WILDLANDS DEFENSE

RE: Kinross Pegasus Exploration Project Draft Environmental Assessment

Here are comments from WildLands Defense and Center for Biological Diversity on the Kinross Pegasus Exploration Project.

Map 35. Manhattan initial treatment area and vegetation condition class departures

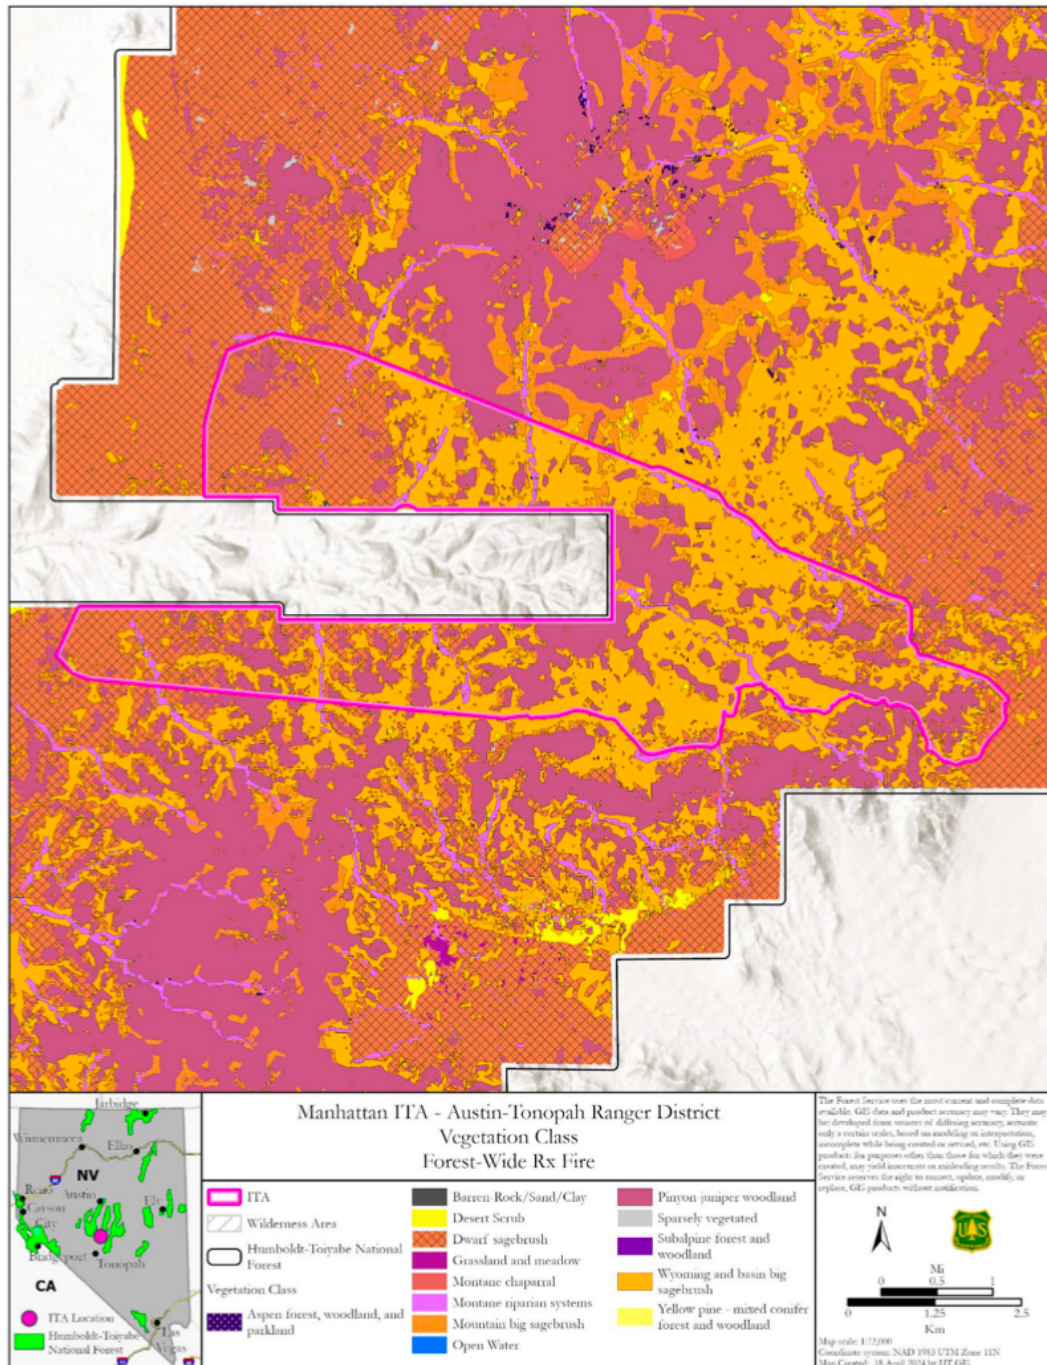
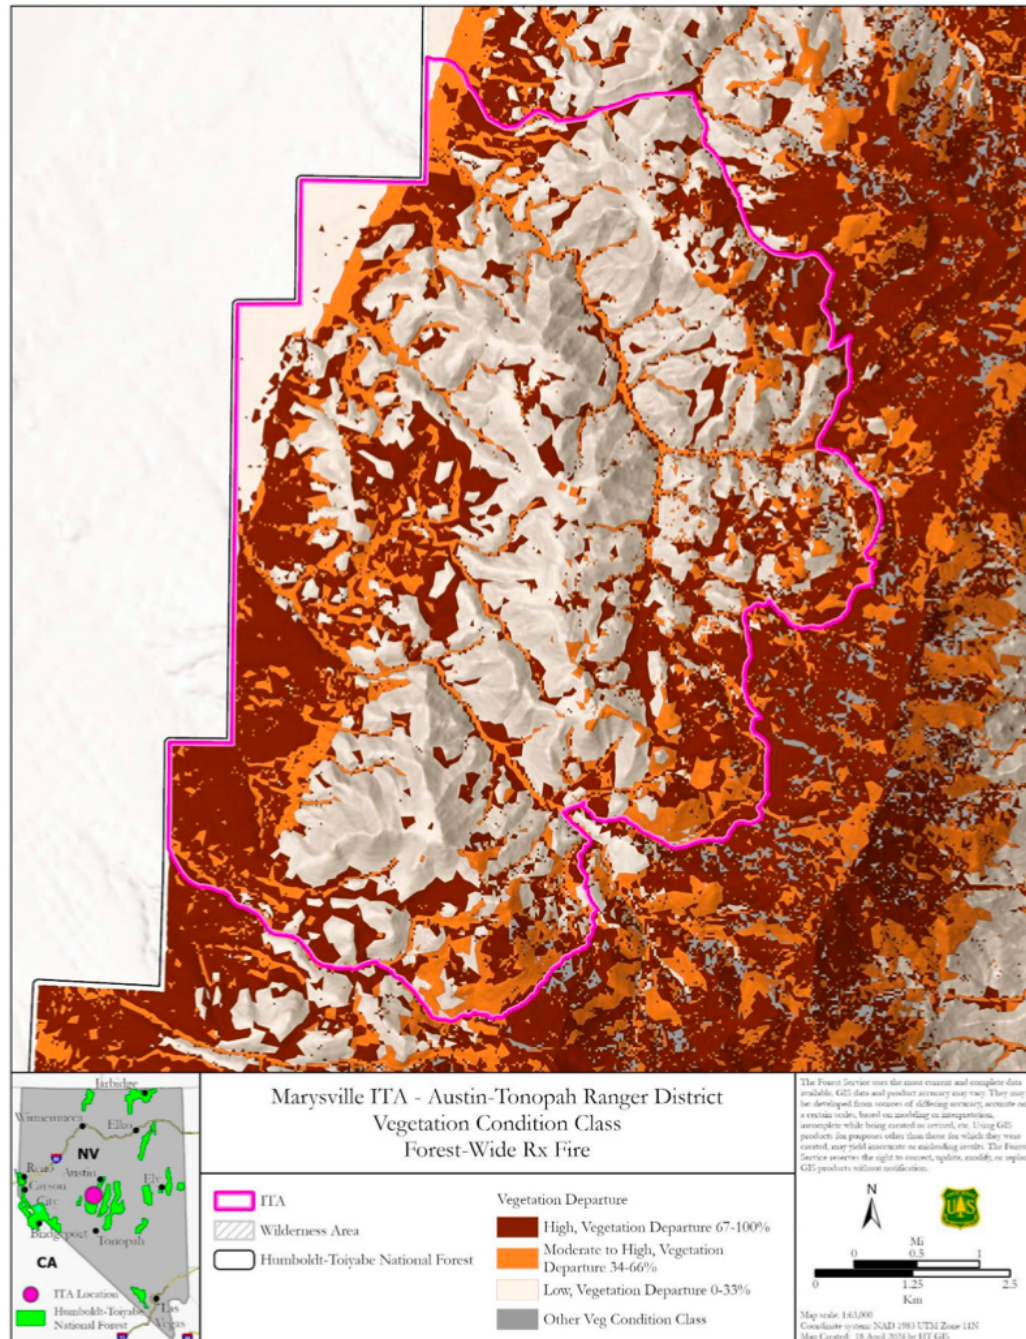
Note that the type of veg modeling the HTNF used in the EA may map areas of extensive PJ forest as sagebrush- because the mapping is based on what is modeled to be there – based on the USFS use of very short fire return interval inputs to the models, and how fire risk is determined.

It's not clear if the white narrow rectangle in the Fire EA is the private land in the EA mapping, or not. Is it?

Please clarify where this Manhattan project and any other Fire EA treatments are located in relation to the Pegasus project land area.
